CENTERVILLE CITY PLANNING COMMISSION AGENDA

**STAFF REPORT
AGENDA: ITEM 1**

PROPERTY: 330 WEST PARRISH LANE

APPLICATIONS: PRELIMINARY/FINAL SUBDIVISION APPROVAL
FINAL SITE PLAN

KING COMMERCIAL DEVELOPMENT

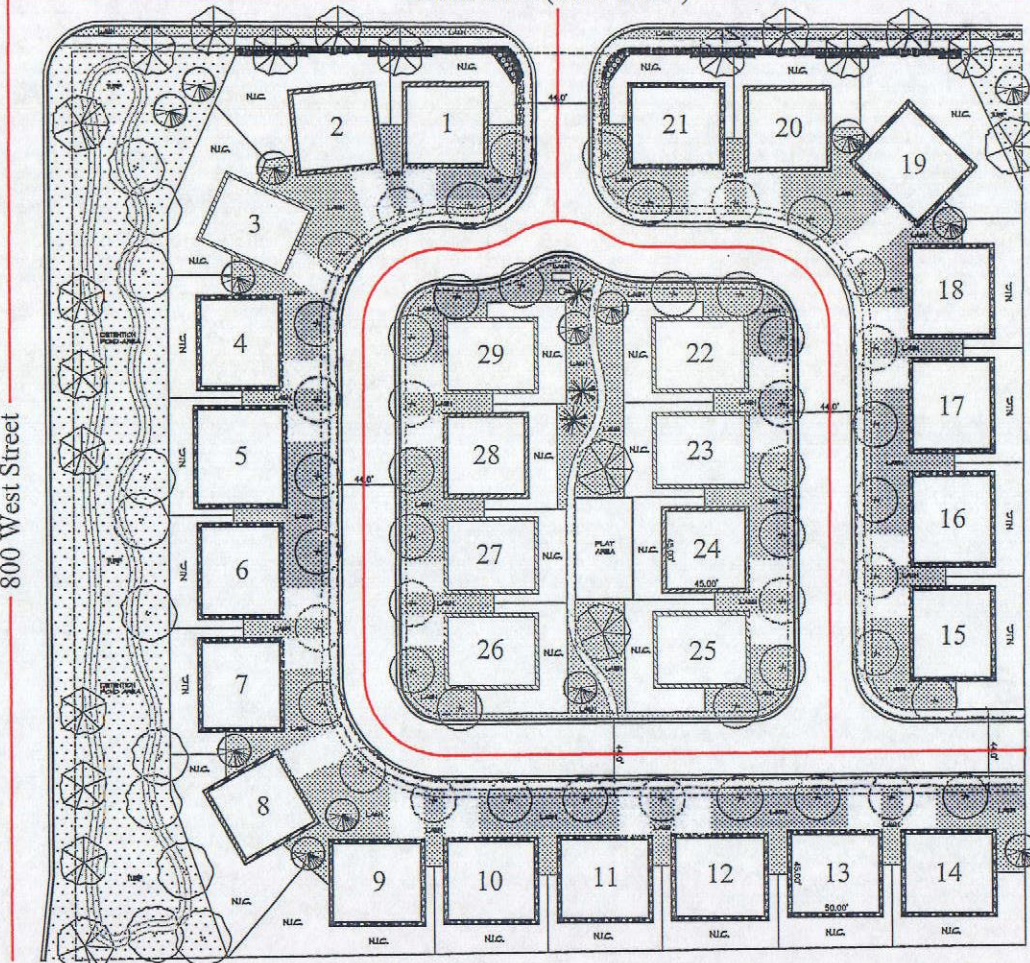
1. All utility improvements, easements and drainage shall be depicted on the preliminary plat and be reviewed by City staff as part of the preliminary/final subdivision review process.
 - *Staff Response: The final site and subdivision submittals are mixed within one another. The final site plan depicts the expected utility improvements, however, the plat is integrated with the site plan and does not provide the required*

easements along the interior lot lines. The subdivision plat needs to be separated from the final site. This will then properly allow the creation of the expected subdivision plat needed for recording.

1. *The subdivision plat shall be separated from the final site plan layout and shall depict the lot layout and utility easement locations in preparation for recording a subdivision plat.*
2. *The City Engineer & Planning Staff shall separately review and make comment to the Planning Commission about whether the subdivision plat complies with applicable subdivision regulations.*

TITLE
LANDSCAPE
PLAN

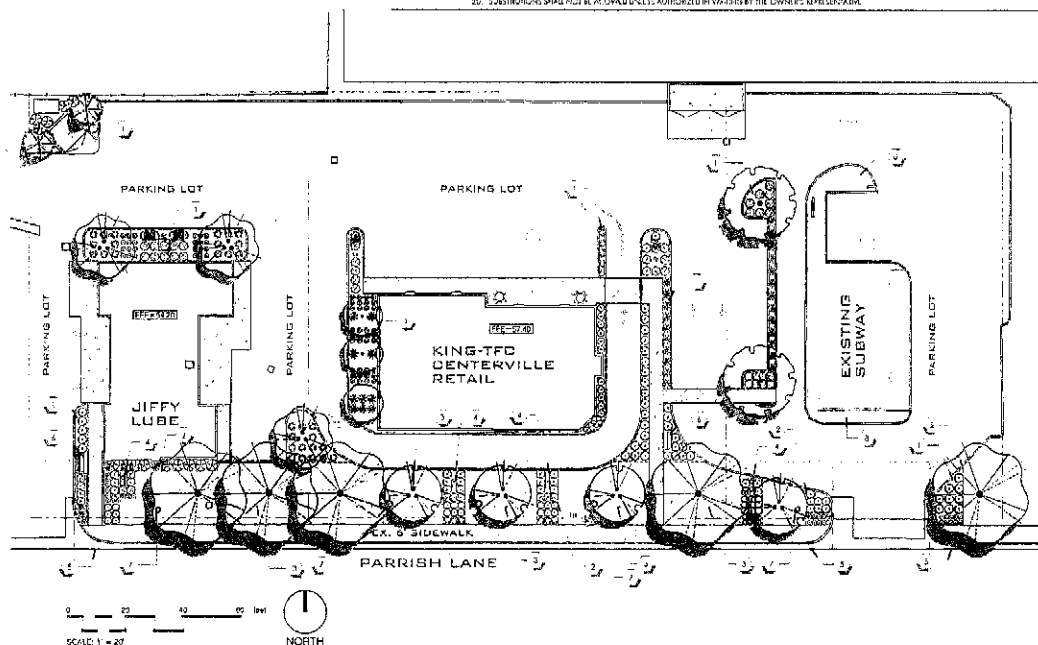
- *Required Street Trees 10 provided – 12 Required; Not Complete*
 - *Total Site Trees 15 required – 19 provided; Complies*
 - *Parking Lot Trees 8 required – 10 provided; Complies*

- *Parking Lot Shrubs 18 required – >18 provided; **Complies***
 - *50% Foundation Landscaping – Lube Center & Subway; **Complies**
Retail; **Not Complete***

- *Berm Landscaping – **Not Complete***
 - *Walkway Landscape Theme; Depicted, **Complies***
 - *Overall Landscaping – Depicted; **Generally Complies**, except where noted.*

- *Parrish Lane Landscape Setback of 20 feet – The gateway standards require 20 feet of landscaping along Parrish Street frontage. At the retail building the plans depict only 17 feet to the drive-thru lane. There is an option for the PC to approve a waiver of strict compliance. Due to the layout configuration, staff is likely to support such a waiver request. However, the applicant has not provided the arguments for a waiver (see Section 12-51-050). **Not Complete***

1. *The landscape plan layout is to be modified to depict the required 50% building foundation planting for the proposed retail building (i.e. Beans & Brew) – Section 12-51-070.c.*

3. *The final site plan submittal is to address the requirements for dumpster enclosure screening - Section 12-51-110.a.*
4. *The applicant shall provide the necessary arguments for a waiver request of the 20 feet of landscaping along Parrish Lane (see Section 12-51-050) for consideration by the Planning Commission.*
